Boston Edison

June 20, 1997
BECO Ltr. 2.97.066

**Additional Information Concerning Pilgrim Station Crediting
Containment Overpressure in the Net Positive Suction Head Analysis
for the Emergency Core Cooling Pumps
(TAC No. M97789)**

Supplemental Information to BECo Response to Question 6 Previously
Submitted in Attachment 1 to Reference 12

Figure 2 - Comparison of Requested Pressure to Containment Pressure Available and Containment Pressure Required

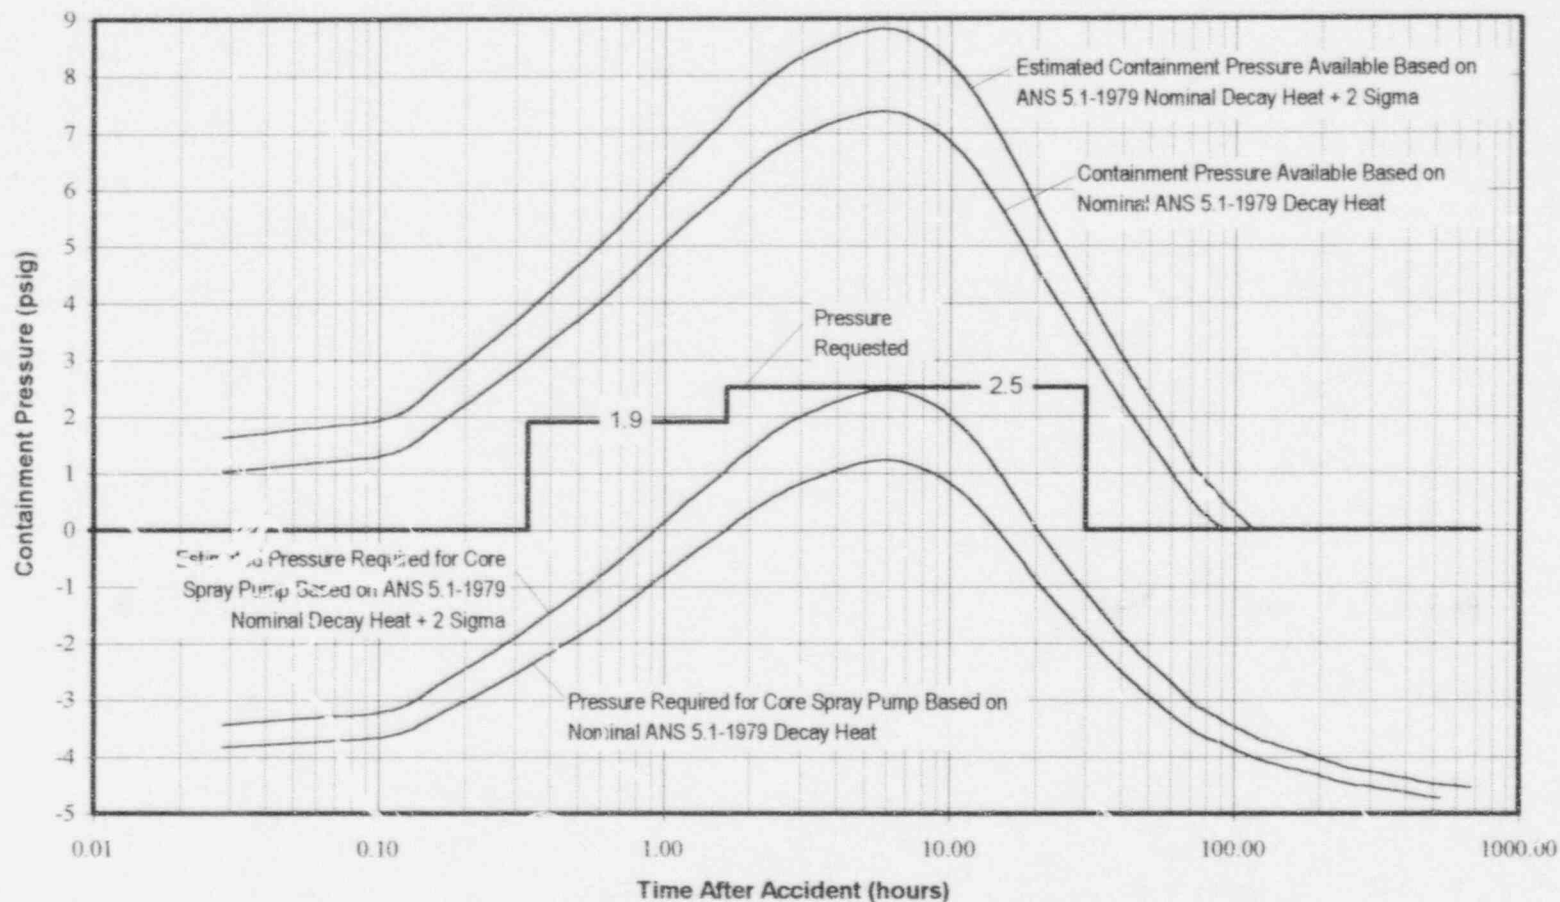
Figure 2 in this response, compares the requested values of containment pressure as a function of time against the containment pressure available assuming 5% leakage of noncondensable gas as illustrated on FSAR Figure 14.5-18. Also included on this figure is pressure required for the limiting ECCS pump(s) which is the core spray pump. However, the pressure required curve for the core spray pump is slightly higher than that shown on FSAR Figure 14.5-18 because the suction line loss was increased by 2 feet to accommodate IST measurement variations, and the pressure required to compensate for debris related head loss of .01 feet was included. As the figure illustrates, the pressure requested is less than that which will be available and greater than that which will be required.

Also included on Figure 2 is the estimated containment pressure available based on the ANS 5.1-1979 decay heat plus a 2 sigma uncertainty adder. The peak pressure available corresponds to the peak suppression pool temperature discussed previously in this response of 185°F. The estimated peak pressure required of 2.46 psig also corresponds with the estimated peak suppression pool temperature of 185°F.

Based on the above NPSH evaluation, BECo requests approval to credit the following amounts of containment overpressure when evaluating ECCS pump NPSH for the limiting DBA-LOCA event:

Time After Accident	Containment Pressure (psig)
0 to 1200 sec.	0
1200 to 6000 sec	1.9
6000 sec. to 30 hours	2.5
